# BCA Assessment Report

Elizabeth Enterprise Precinct  
Industrial Facility (WH2)

Mirvac

**Revision 3**

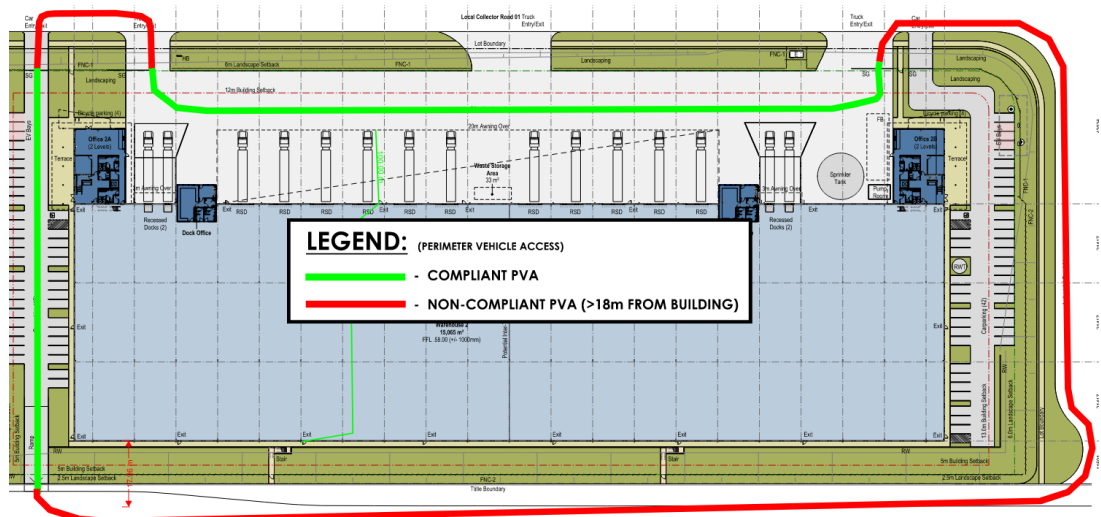
**Comment:** The perimeter vehicular access to Warehouse 2 deviates from the above requirements as follows:

- + Greater than 18m from the external walls in the areas highlighted in red.
